Refining TDECQ (continued)

Piers Dawe

Mellanox

Not all maximum-TDECQ signals are equal

TDECQ map

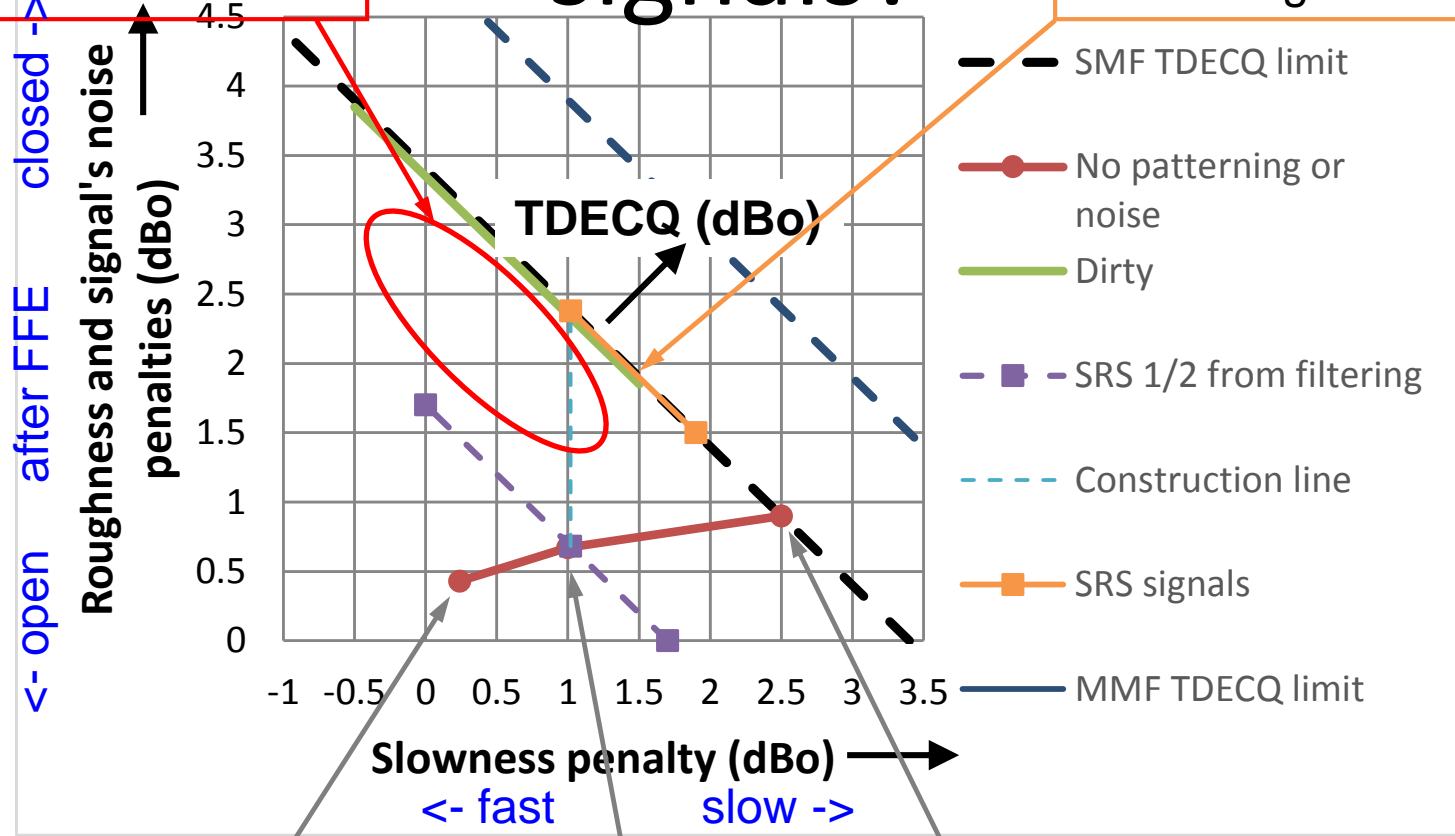
Mismatch between SRS and real signals?

Where will real poor signals be? Here?

Don't support unrealistic bad scenarios

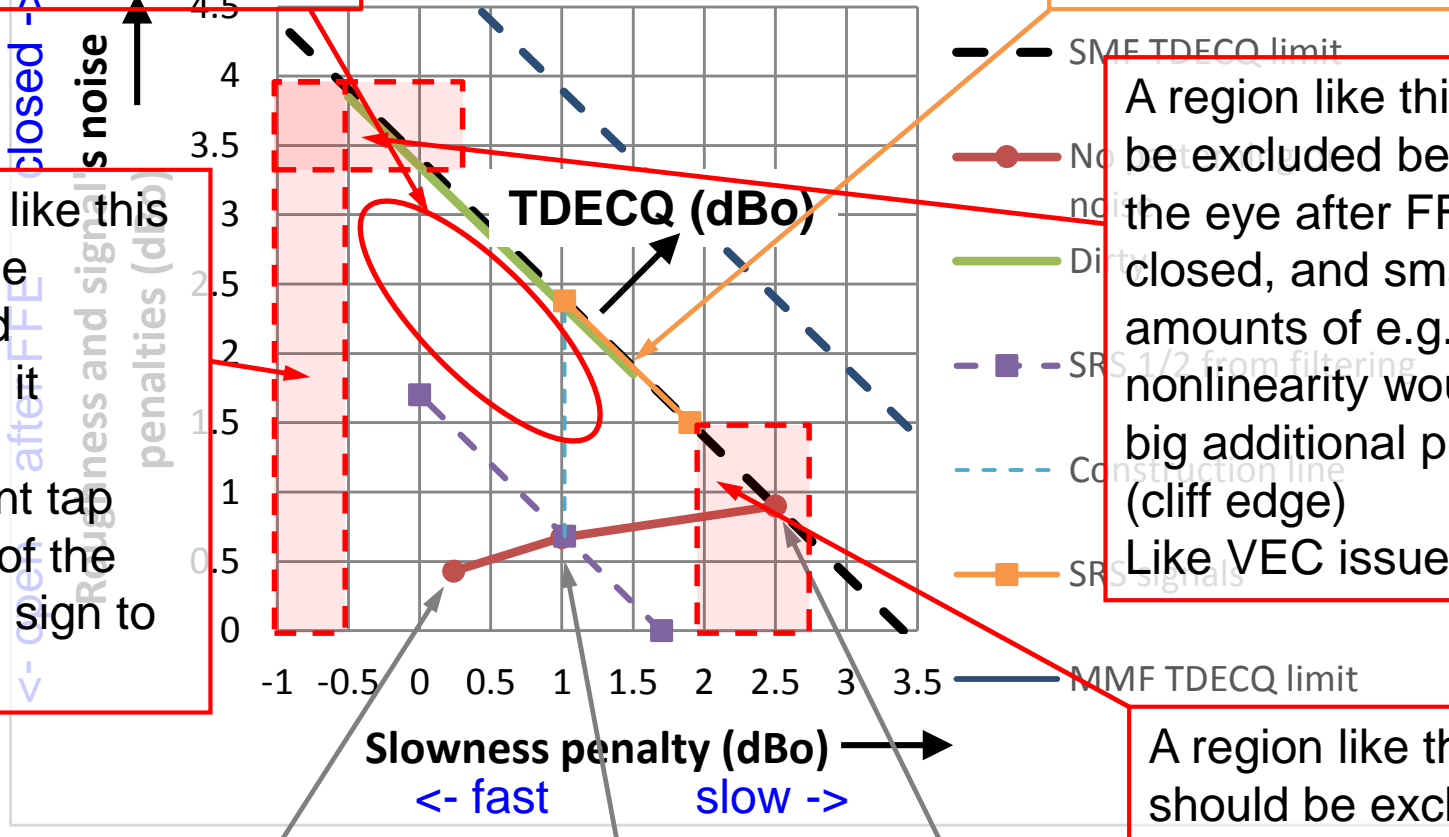
A region like this should be excluded because it requires significant tap weights of the opposite sign to normal

A region like this should be excluded because the eye after FFE is very closed, and small amounts of e.g. nonlinearity would cause big additional penalties (cliff edge)
Like VEC issue in C2M

A region like this should be excluded because it requires strong tap weights not useful in practice, and is not screened for in SRS

"Exclusion" could be by giving signals in the red boxes worse TDECQ scores, or by "hard" pass-fail rules

Extremes of worst-case signals

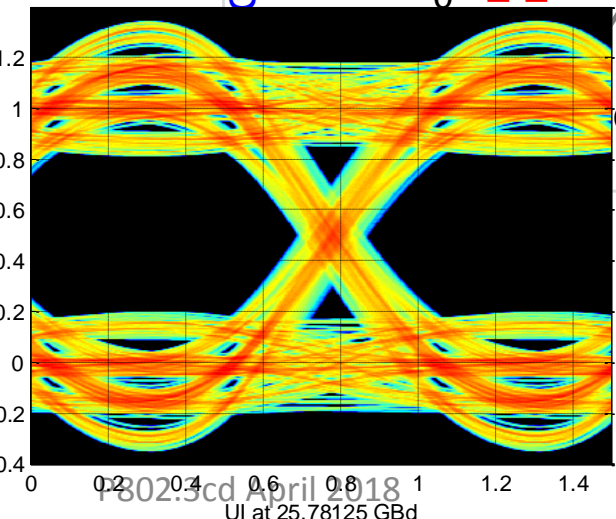
The signal on the left is bad because nothing can be done to improve it – neither sensitivity nor EQ. Worse is allowed by the draft
